Review of Powhatan Salt Company
Solution Mining Well Permits for Storage of Natural Gas
Liquids at the Mountaineer NGL Storage Facility near
Clarington, Ohio

Dominic DiGiulio, PhD
Robert Rossi, PhD

March 24, 2021

Figure 5. Modified screen shot from the ODNR Oil and Gas Well Viewer illustrating the locations of salt solution mining wells (Salt 1, Salt 2, Salt 3), location of Core Hole 1, horizontal extensions of hydraulically fractured oil and gas wells, and 100-year floodplain (shaded blue)

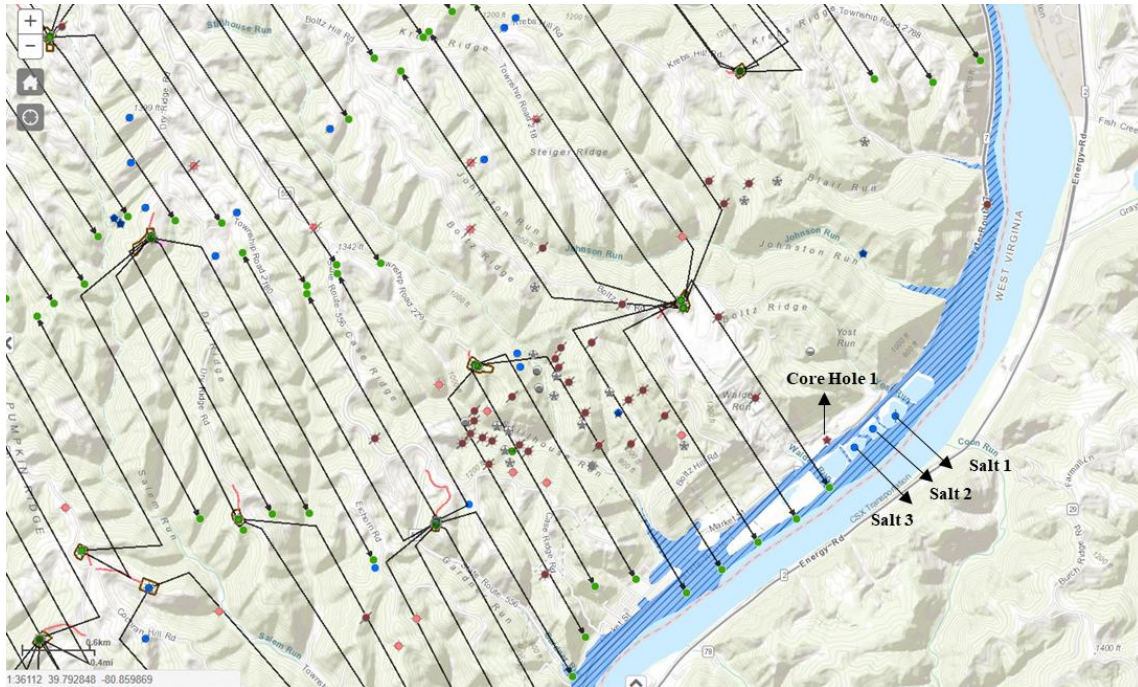
Contingency for Flooding					As illustrated in Figure 5, all 3 salt solution mining wells are within a 100-year floodplain. The operator needs to specify what contingencies are necessary in the event of flooding.	No response
Cavern Integrity Monitoring						
Cavern Integrity Monitoring Program		X		X	API 1170, 1171, and 1115 require that the integrity of the well and salt cavern system must be maintained and monitored. Once in operation and throughout its life, a cavern system must be monitored to ensure functional integrity. There must be a formal written integrity monitoring program that must contain, at a minimum, the following components: (1) identification of cavern system components to be monitored; (2) monitoring methods specifying the type of method and frequency of application; (3) cavern volume and growth monitoring; (4) analysis of data from inspections, reporting, and archiving of results; (5) periodic reviews of the monitoring program for effectiveness; and (6) subsidence monitoring. The permit application does not contain a formal written integrity monitoring program. This is absolutely critical for safe operation of NGL storage. PSC must include a cavern integrity monitoring program in permit applications or describe when a cavern integrity monitoring program will be provided to the ODNR.	No Response
